MEMO

Department of Water Resources

Subject: Boise State University Application for Permit for Cooling

Figure1. Generalized geologic cross section using the BSU Liberal Arts well and three surrounding wells.

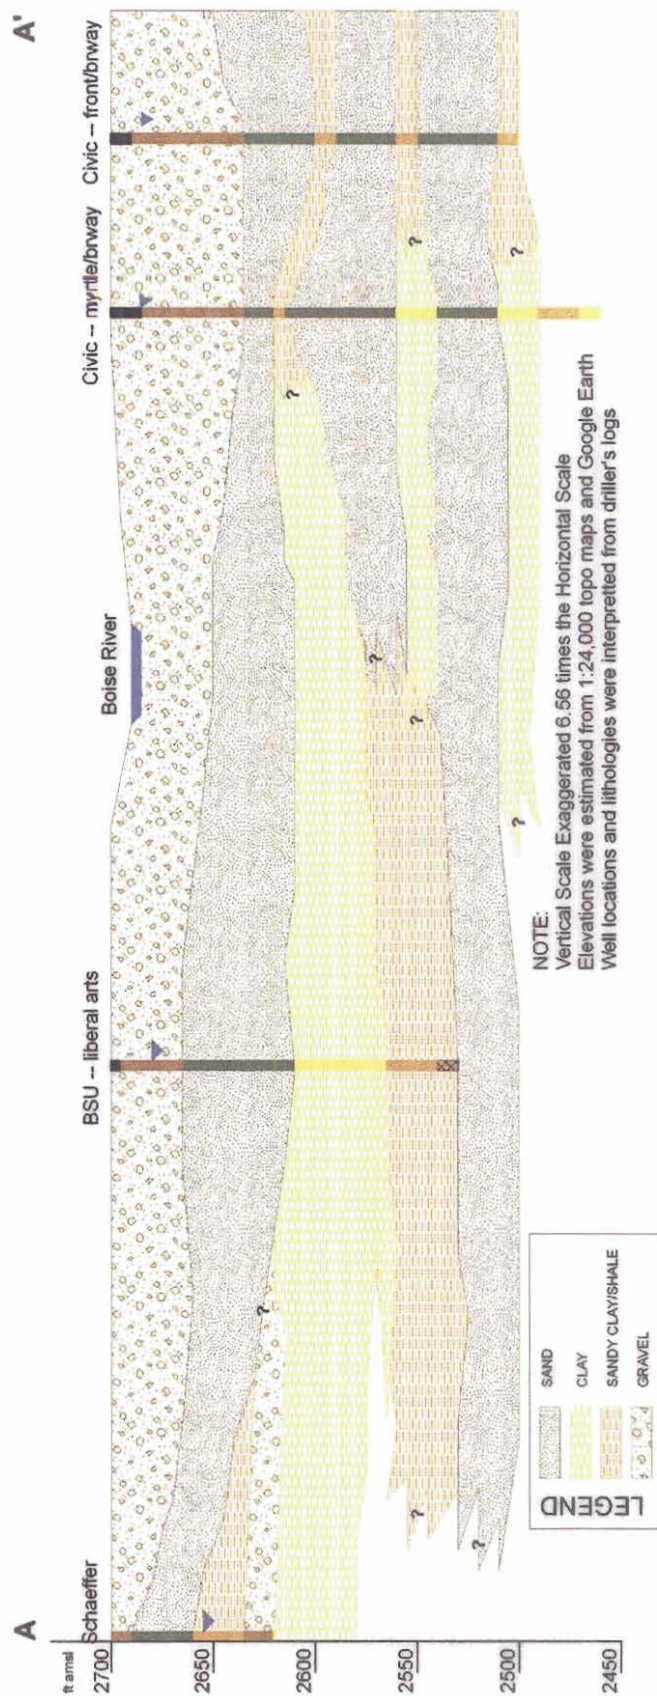
The driller's log provides a summary of the lithologic units encountered when drilling the well. The upper 30 feet of the subsurface is composed of gravel and top soil overlying a 60-foot thick saturated sand unit. This saturated sand unit represents the shallow aquifer and is separated from the intermediate aquifer system by the 80-foot thick sequence of clay and shale. Below the clay and shale units lies the sand unit that represents the intermediate aquifer. The individual sand, gravel, and clay units of the area appear to be laterally discontinuous, as shown in Figure 1.

The ground water being diverted in this application is from the intermediate aquifer at a depth of approximately 170 feet bgs. Hydraulic connection of the producing zone to the overlying shallow aquifer has not been shown. Based on the existence of over 80 feet of low permeable unsaturated clay and shale separate the shallow aquifer system from this intermediate aquifer, the degree of hydraulic communication between the two aquifers is minimal.
